# ACHANY EXTENSION WIND FARM

Additional Information  
Planning Statement

April 2022

**Figure 2.2**  
The Revised Layout - Proposed Changes

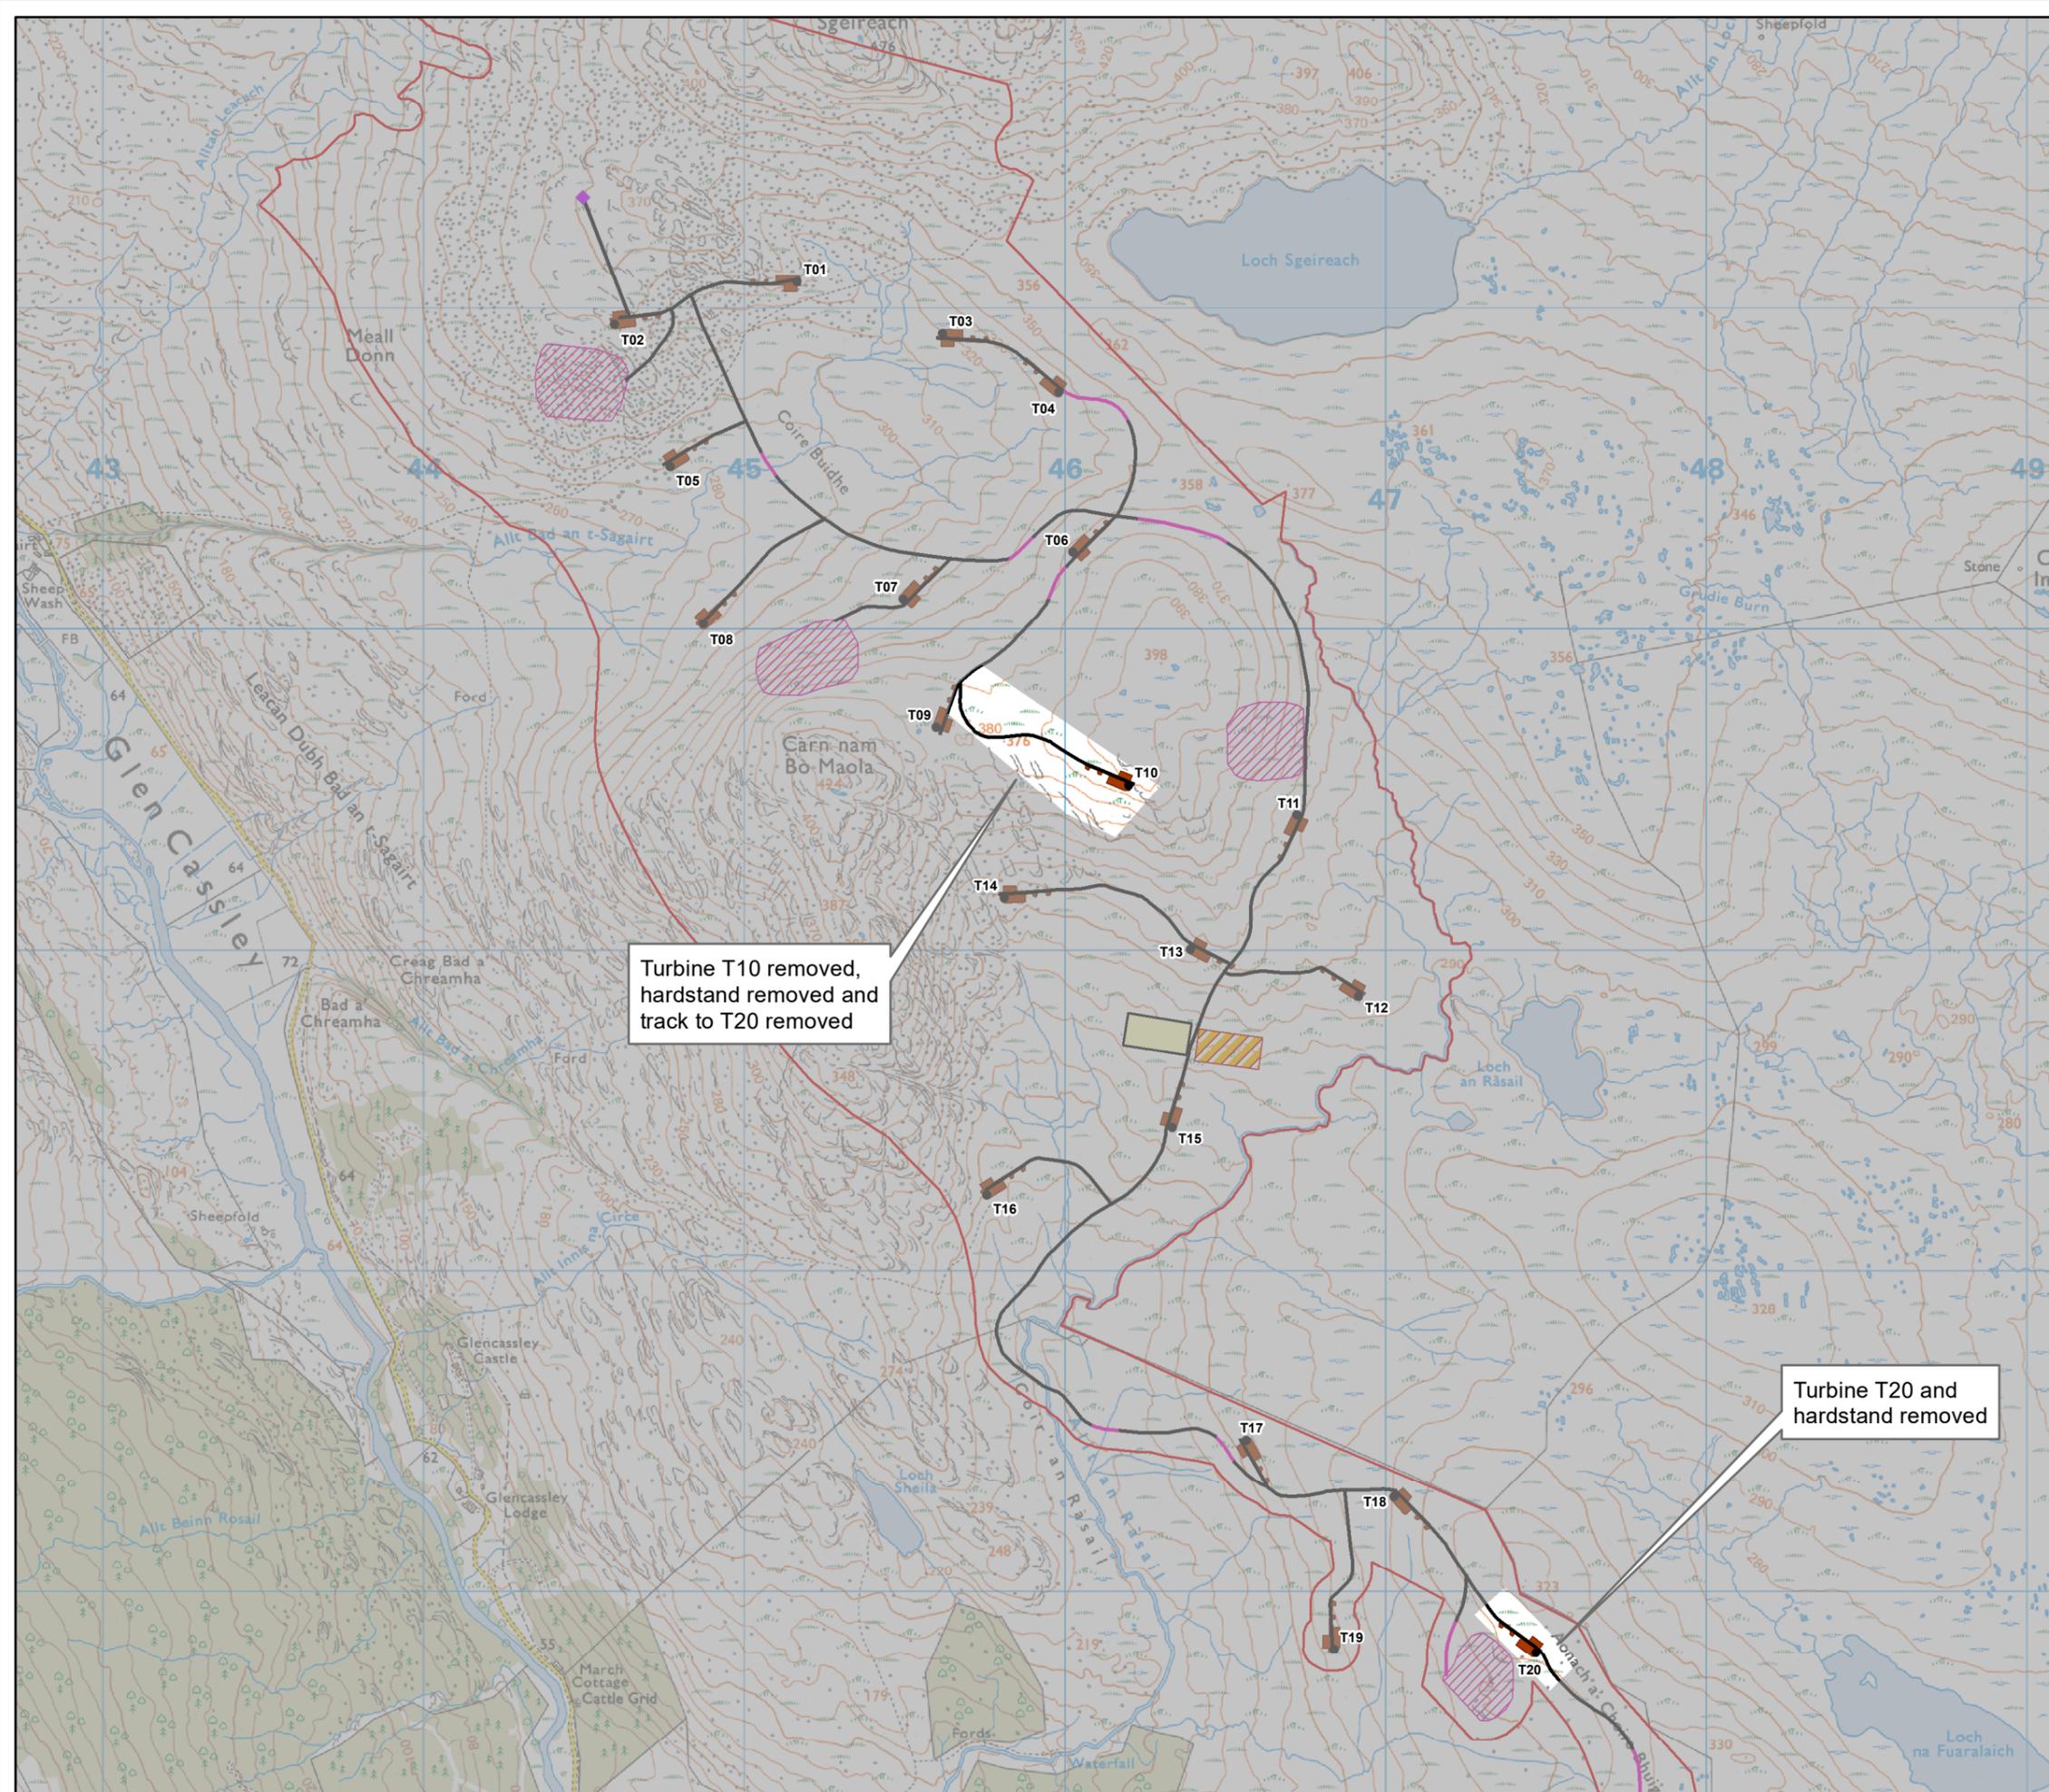
Turbine T10 removed, hardstand removed and track to T20 removed

Turbine T20 and hardstand removed
